Redrow Homes - Hesmond's Stud Detailed Planning Application WD/2022/0341/MAJ

# Village Concerns Objection 17 - Officer's Report Rebuttal

The Correct ESCC Rights of Way Map for the site.

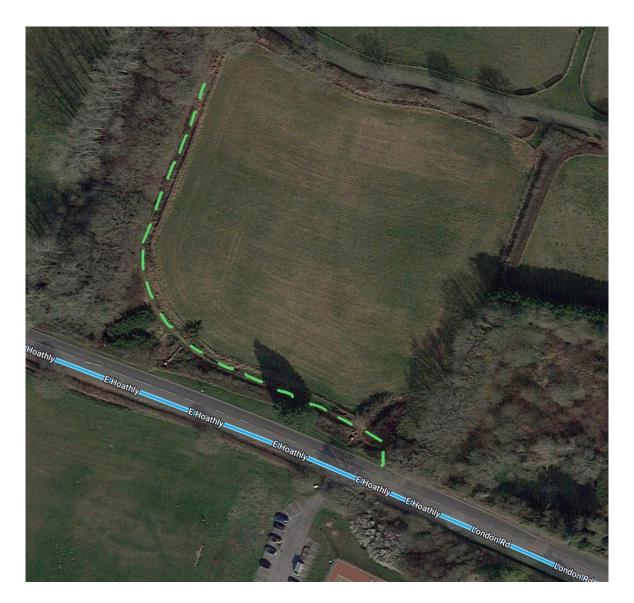
38. Figure 3 of the Officer's Report shows what is claimed to be the right of way crossing the site. This is not the correct map, the correct ESCC rights of way map is shown below:
